November 29, 1984

Cecil O. Thomas, Chief
Standardization & Special Projects Branch
Division of Licensing
U.S. Nuclear Regulatory Commission
Washington, DC 20555

The enclosed materials are submitted in support of the University of Utah's application for renewal of its TRIGA Nuclear Reactor Operating License, R-126, Docket No. 50-407.

UNIVERSITY OF UTAH TRIGA REACTOR (UUTR)

Fig. 8.5.1 Transient power and fuel temperature as functions of time after 2.25% $\delta k/k$ (\$3.00) reactivity insertion.

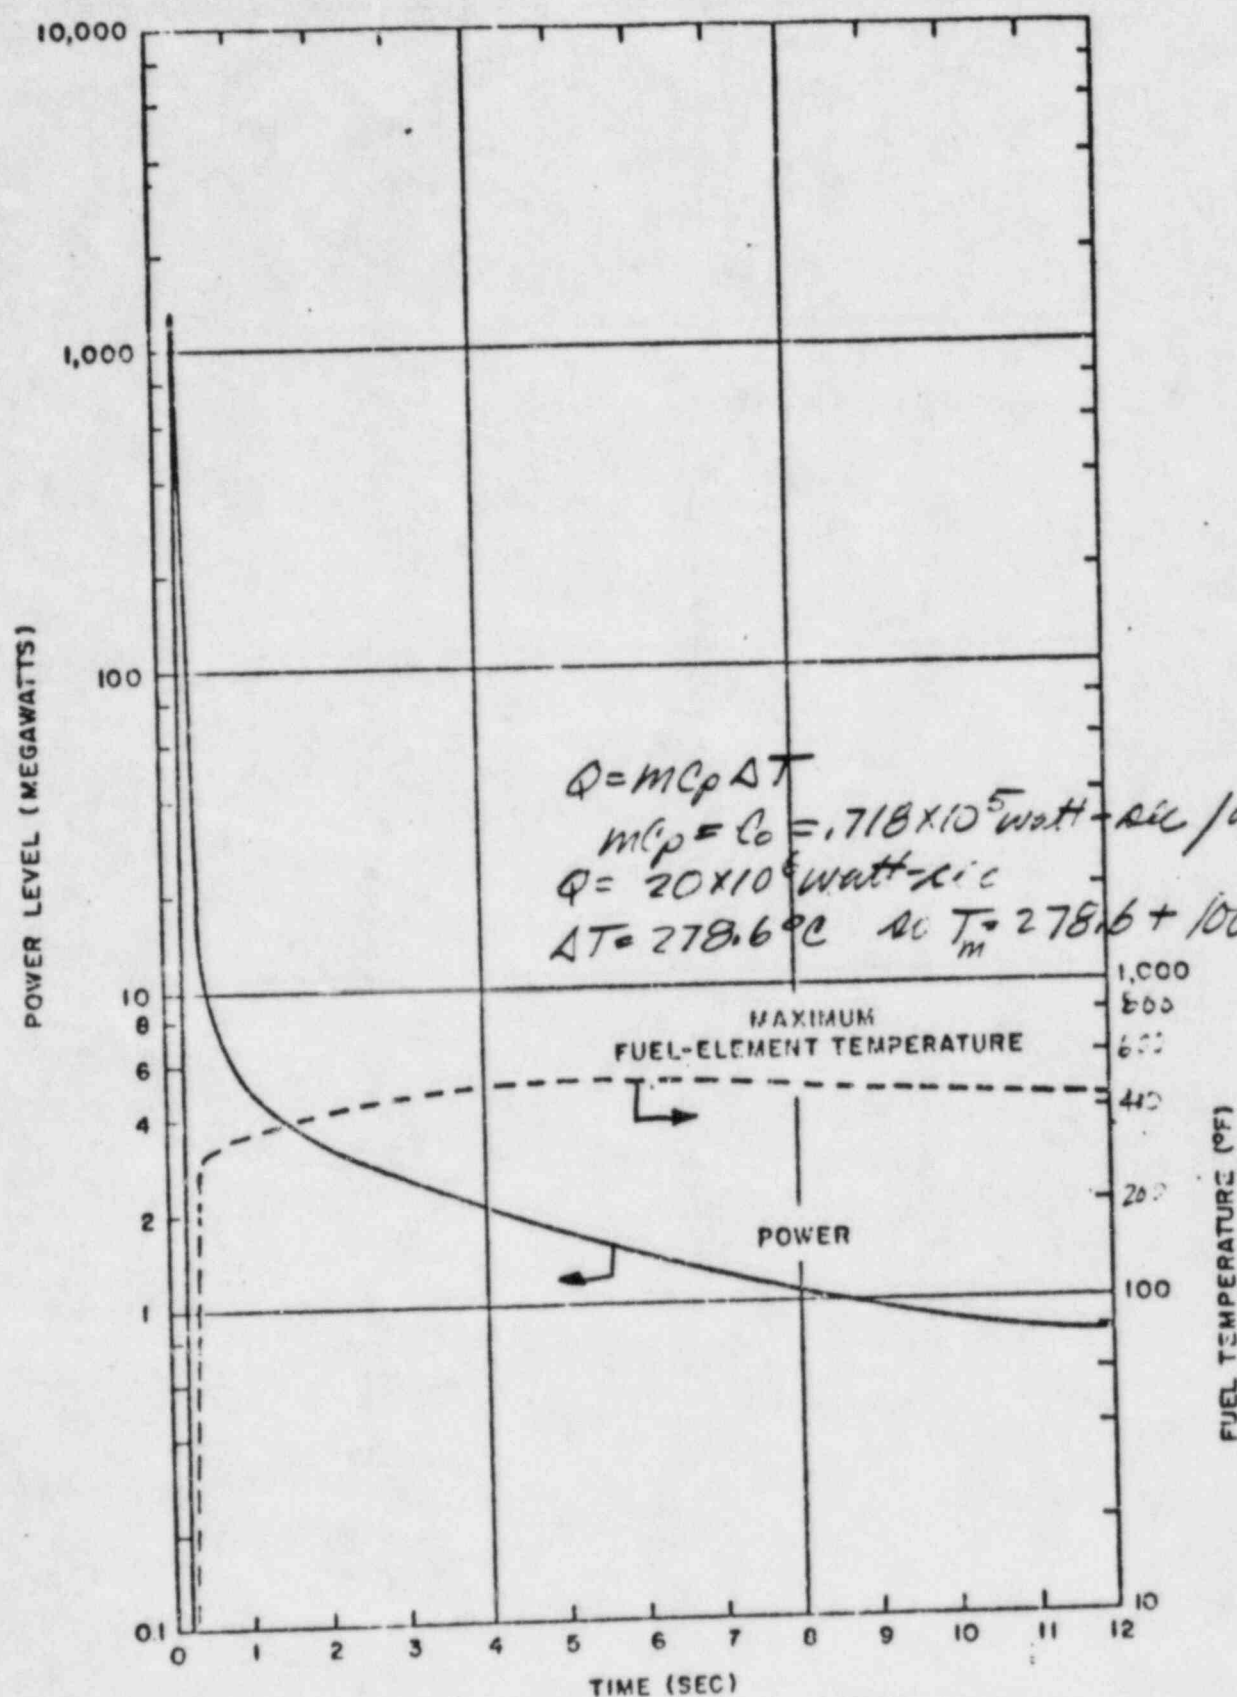
24. Please address the following accidents; include all assumptions made, calculative methods used, accident scenarios, and references to any documents.

The reactor fuel loading under the Technical Specifications can provide a maximum of 2.25% Δk (\$3.00) excess reactivity above a cold, critical condition. In this section it is conservatively assumed that the core is loaded so that all of the innermost fuel positions contain fuel, starting from the central fuel (or B) ring, which consists of six elements. The maximum reactivity transient which could possibly occur would be that produced in such a densely packed core by the accidental insertion of the entire available amount of excess reactivity instantaneously.

Figure 6.1
University of Utah Administrative Organization
for Nuclear Reactor Operations

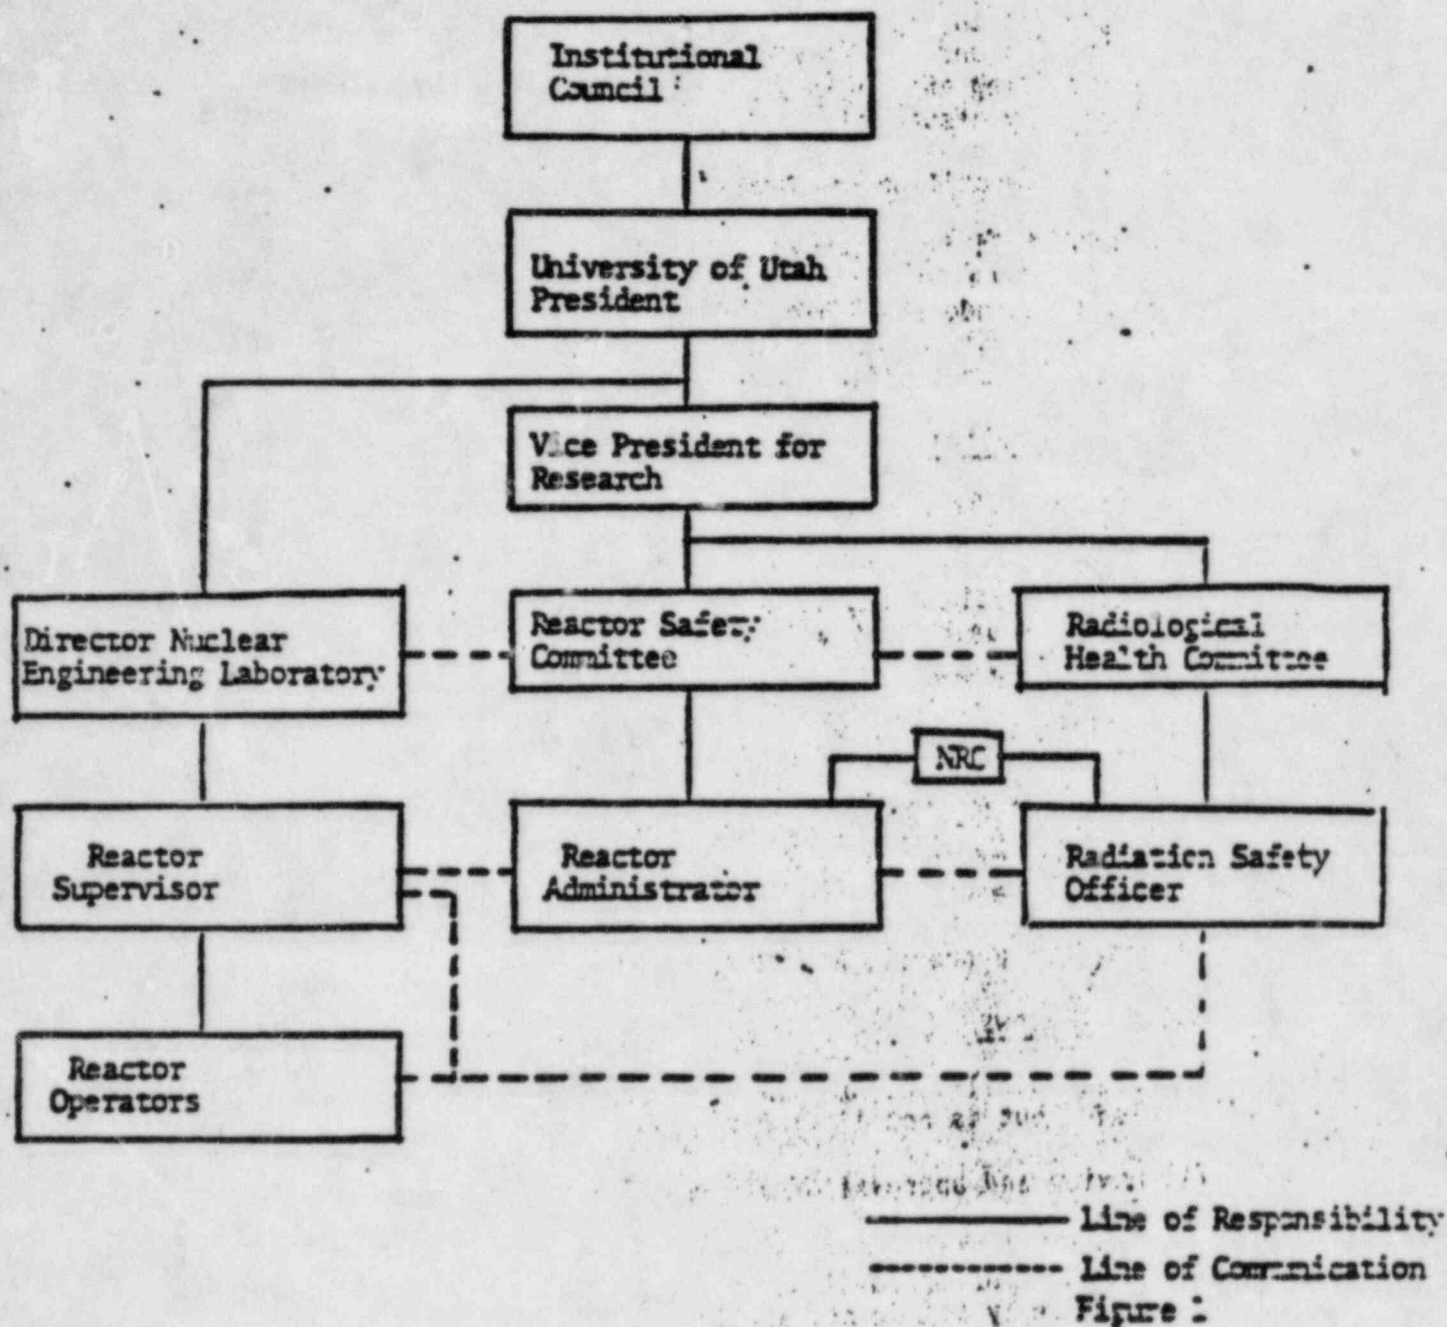
43. Describe any radiation protection training for the non-Health Physics staff. If possible, provide a topic outline of the courses and indicate the normal duration of each course or lecture.

The radiation protection program at the University of Utah is administered by the Radiological Health Office with a Radiation Safety Officer. The attached figure provides the administrative organization structure. The Institutional Council of the University of Utah is the licensee for the TRIGA reactor to the NRC. However, the Reactor Administrator is the primary point of contact with the NRC in behalf of the Institutional Council. The reactor Safety Committee and Radiological Health Committee serve as review and approval bodies for all activities which are under the primary control of the Reactor Supervisor. The Reactor Supervisor is responsible for all reactor operations and operators in the Nuclear Engineering Laboratory.
